# Appendix 4

## Tomingley Gold Project Narromine to Tomingley Pipeline Operational Condition and Ongoing Maintenance Costs

## OzArk Response to OEH Queries over the Tomingley Gold Project Biodiversity Offset Strategy and BioBanking Credit Calculations

## Additional Flood Modelling and Flood Heights - Tomingley Gold Project (SEEC)

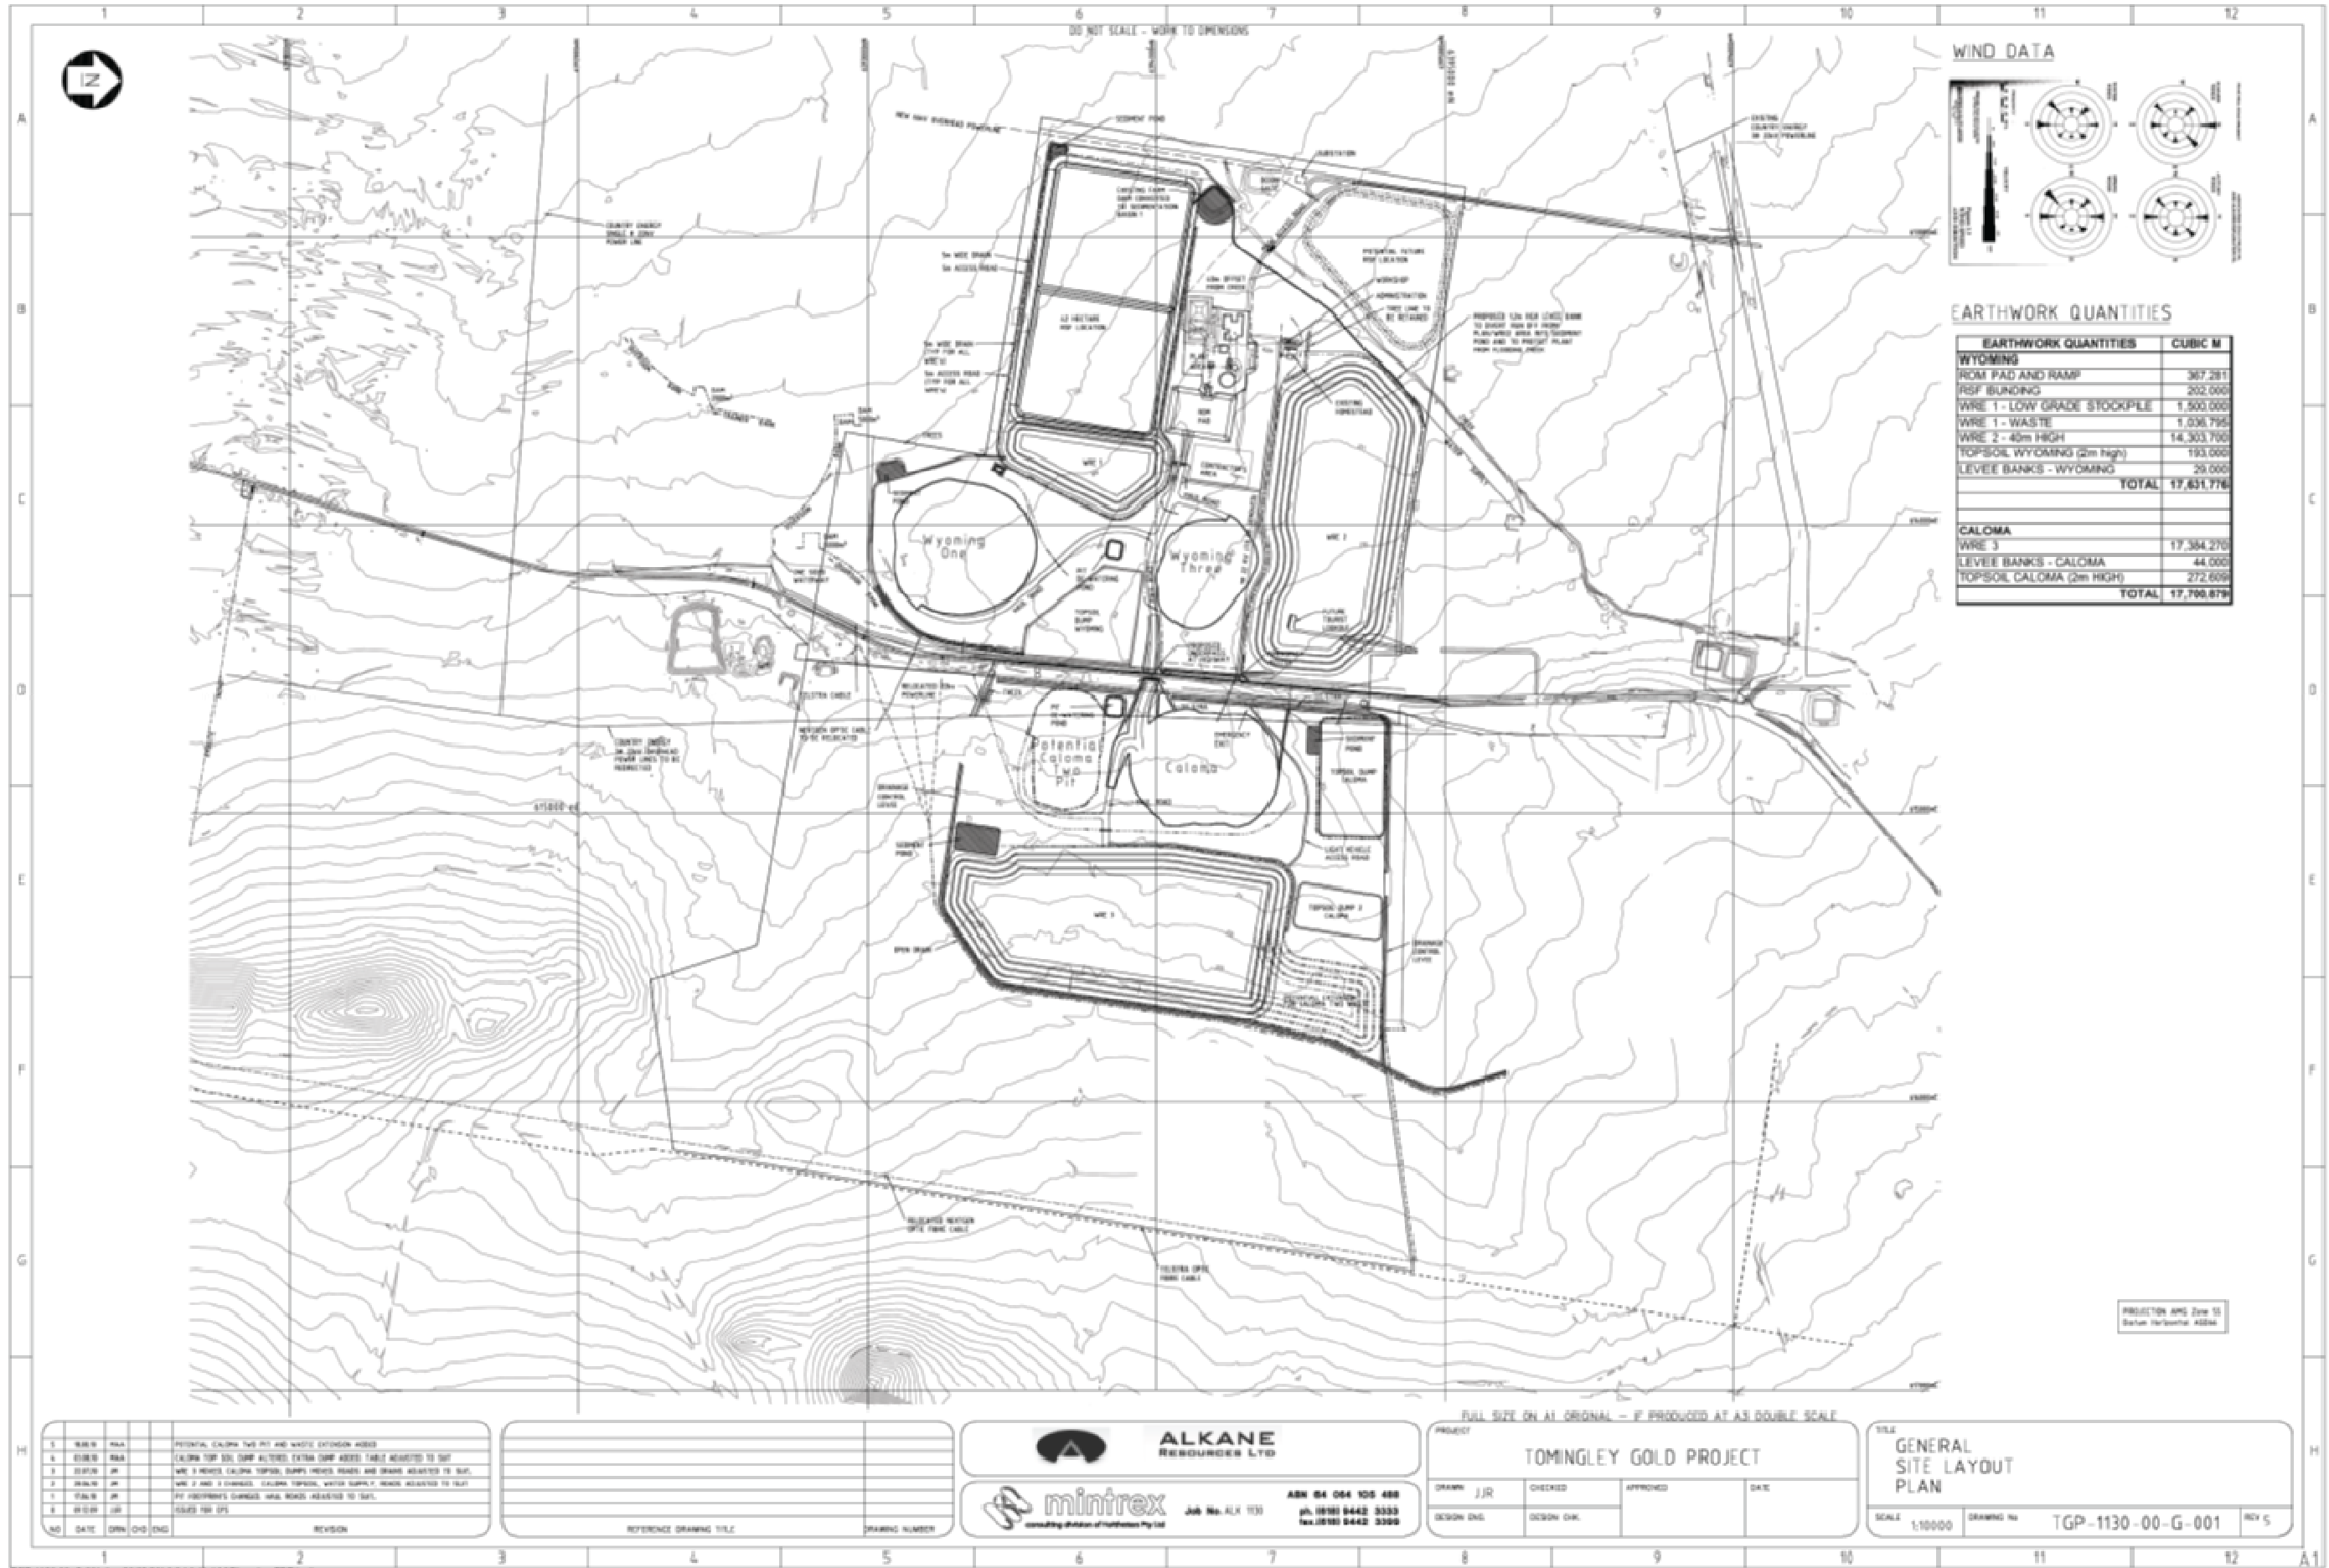
**Issue:** Some inaccuracies remain in the proposed Biodiversity Offset Strategy (BOS). Clarification of the area to be included in the offset is required.

1. To accommodate the Eastern Surface Water Drainage Structure the Proponent will be required to remove a small (30m x 30m) patch from the remnant vegetation (of Community 3). This has increased disturbance by 0.1ha and reduced conservation by 0.1ha.
2. The area of Community 4 conserved has been reduced to 1.9ha as it has been identified that 3.0ha of the original area was located on land for which the Proponent holds an agreement with the land owner. It is noted that areas to the south of the Mine Site on the eastern side of the Newell Highway identified in the

original Figure 2.19 were not included in BioBanking calculations and have also been removed from Figure 2.19 (modified).

**Response:** The Proponent has re-issued a figure (**Figure 2.19 (Modified)**) showing the location of offsets (vegetated area to be removed has not been highlighted). You will note that there are two main changes to the areas identified on the original *Figure 2.19* of the Environmental Assessment (and *Figures A10.1 and A10.2* of the Biodiversity Assessment) and included in the BioBanking credit calculations.

With respect to Figures A10.1 and A10.2, the discussion related to the isolated paddock trees provides the detail required from your query. Figure 2.19 (Modified) has been provided for your perusal.

Figure 1 Results of additional flood modelling (100-year ARI event), showing the extent of change in flood heights around the Project Site.

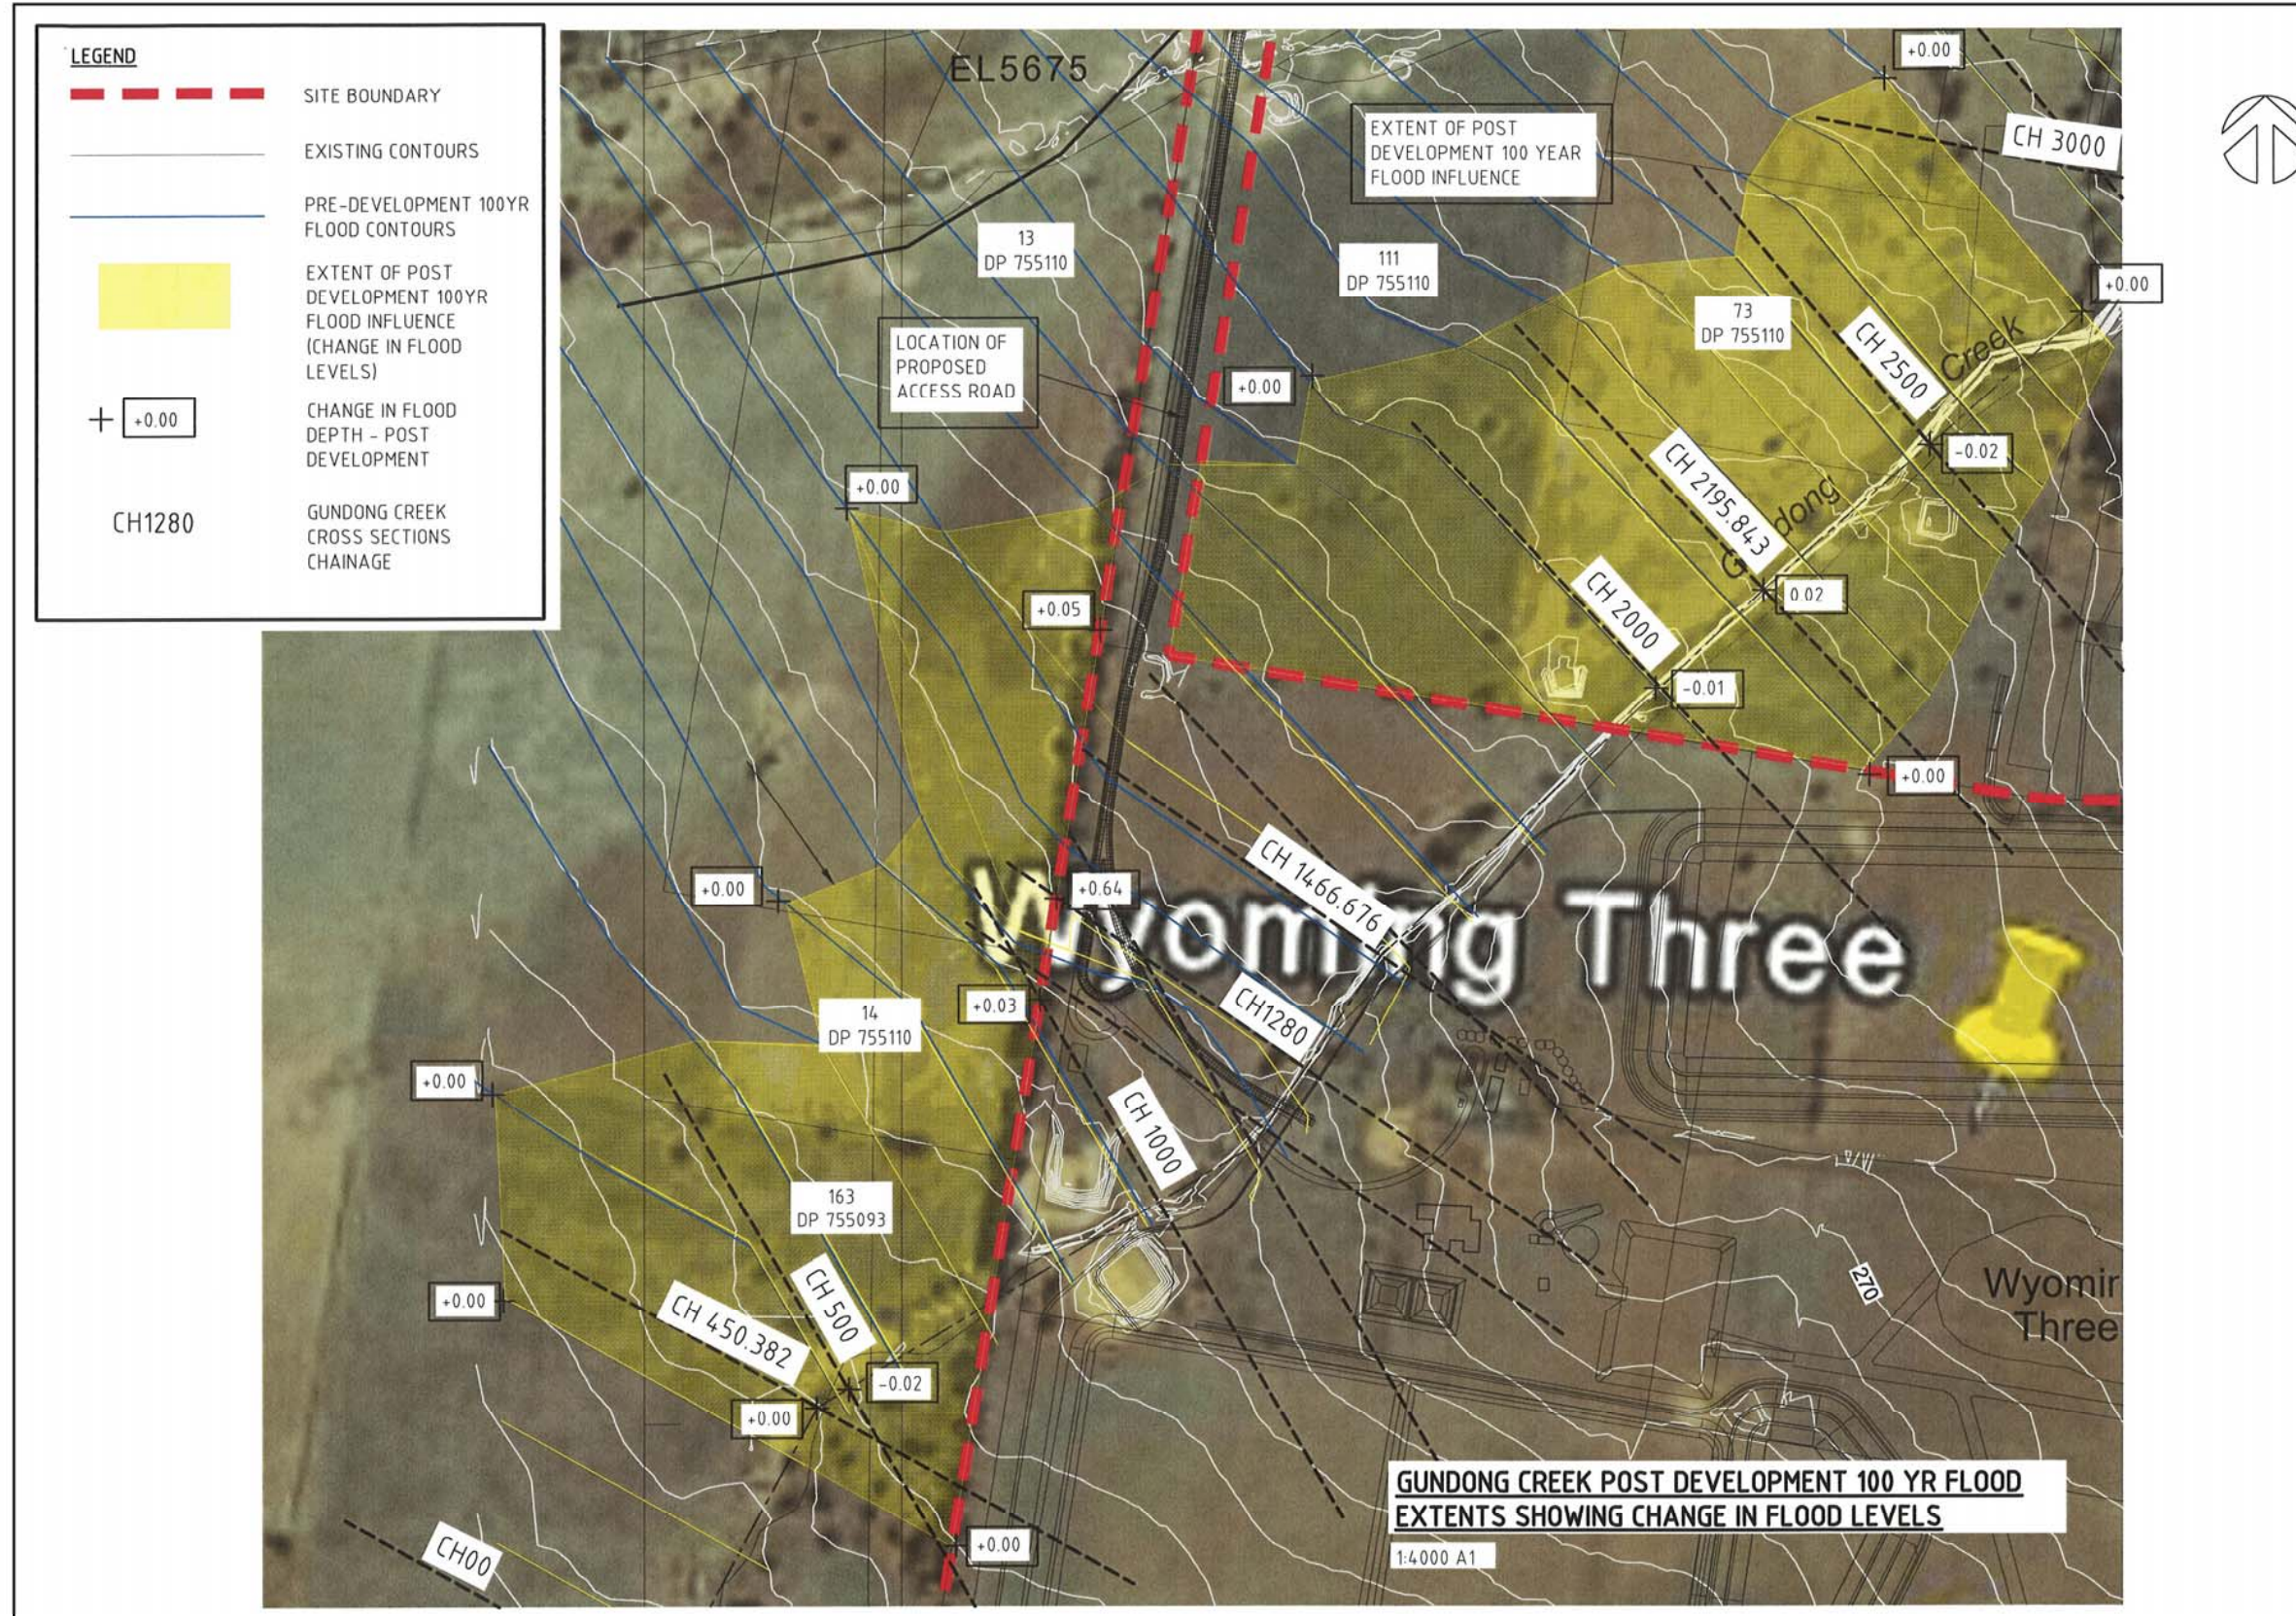
In response to our discussions with Tim Baker from NSW Office of Water on 25 January 2012, we have conducted additional flood modelling around the Tomingley Gold Project site. Following are the results of that modelling.

**Figure 1** below shows the results of additional flood modelling around the Project Site for the 100-year ARI event. The purpose of this modelling is to show the extent of change in flood heights on adjacent properties. The hatched area shows the limit of the changed flood heights - beyond that zone, modelling shows no change. Spot height changes note where flood levels will either decrease (negative values) or increase (positive values).

The maximum change is an increase of +0.64m, where an aflux occurs immediately upstream of the site access road crossing over the site bund. As can be seen from the spot heights, this increase quickly dissipates on the adjoining lands to the point where no impact occurs. As a result, the area of land impacted by an increase in flood height is relatively minor.

Note that the results shown in **Figure 1** differ slightly from those presented in the Surface Water Assessment (SEEC, 2010). This is as a result of slightly different model calibration although this variation is not significant. The results presented in the Surface Water Assessment (SEEC, 2010) are still considered valid as they are inherently conservative.
